# **PLANNING & ZONING AGENDA ITEM #5**

***SUBJECT:*** Approval of a Site Plan for Dartmoor Retail Center II [53 – 95 NE Dartmoor Drive]

RE: Dartmoor Retail Center II

Per your request, staff and Veenstra and Kimm have reviewed the Site Plan for the Dartmoor Retail Center II located north of the Hickman Road/Dartmoor Drive intersection adjacent to Heartland Tire and Auto. Based upon our joint review, we have the following comments to offer regarding the site plan:

① WEST ELEVATION  
3/32" = 1'-0"

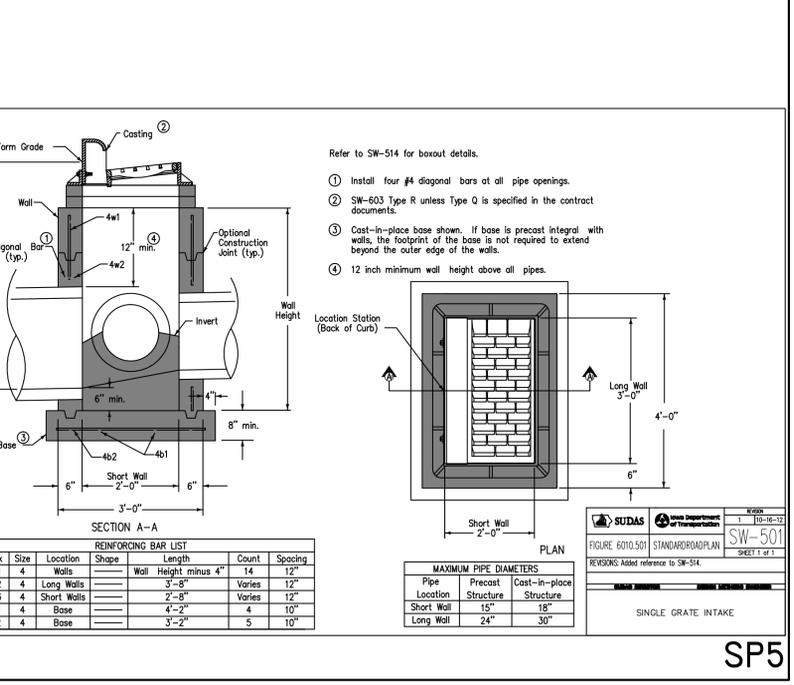
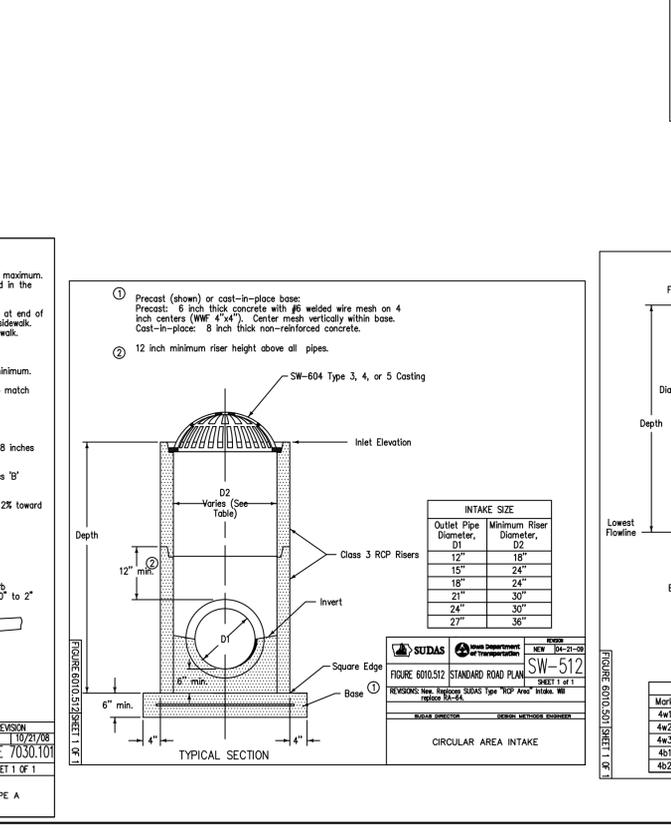
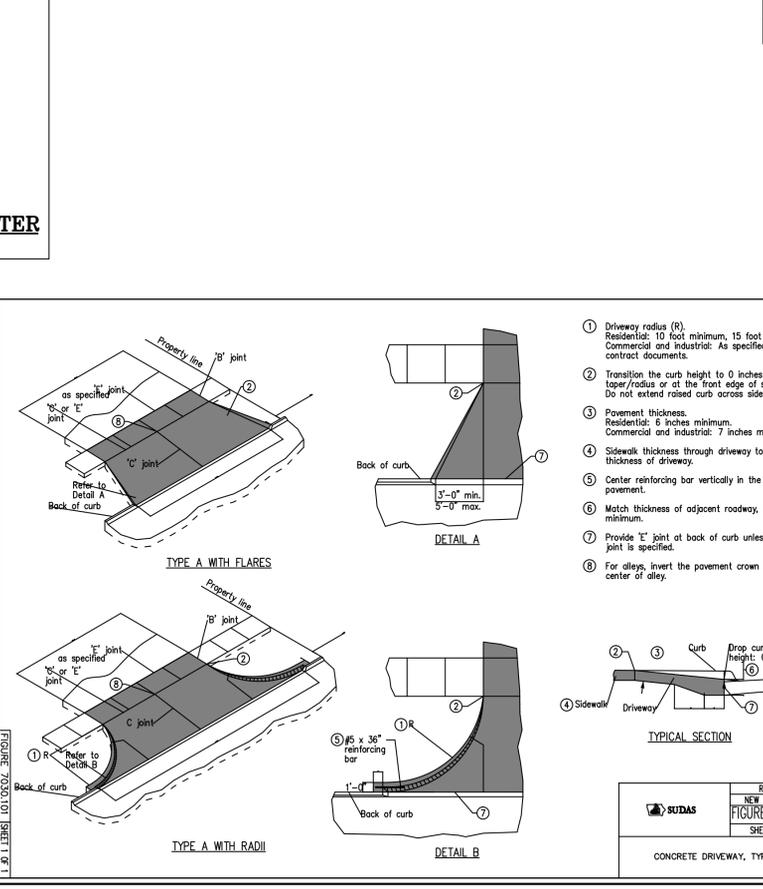
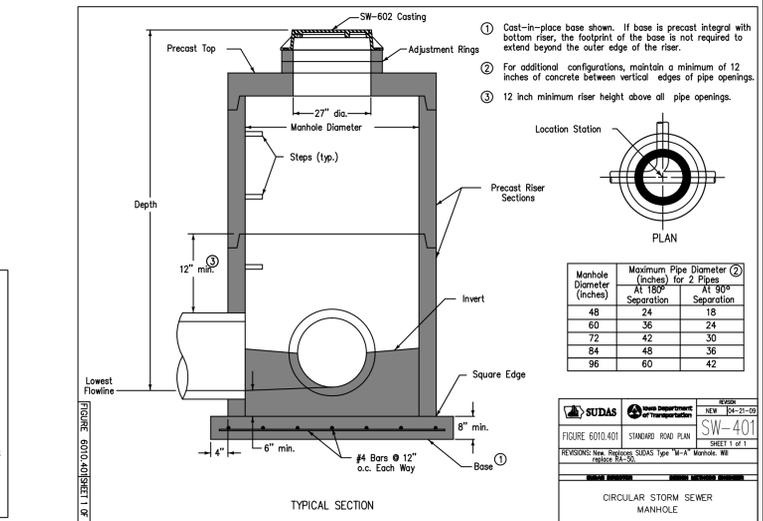
39. The colored elevations should be updated to provide massing dimensions for each elevation.
40. While the recently approved changes to the site plan ordinance, and in turn the architectural provisions, eliminating specific material percentages the ordinance is not intended to require 360 degree architecture. With this in mind, Staff would like to see some additional thought given to the rear (east elevation) that would provide a similar level of interest as the other portions of the building. Attached is a copy of the new site plan ordinance outlining the specific provisions that need to be met by this project.
41. A note should be added to the elevation drawings indicating the mechanical screening to be adjusted as necessary to provide for adequate screening of the units.

42. ~~A note should be added indicating signage to be reviewed and approved by the Development Services Department under separate permit.~~
43. **Material samples of the building should be available at the Planning and Zoning Commission and City Council meetings.**
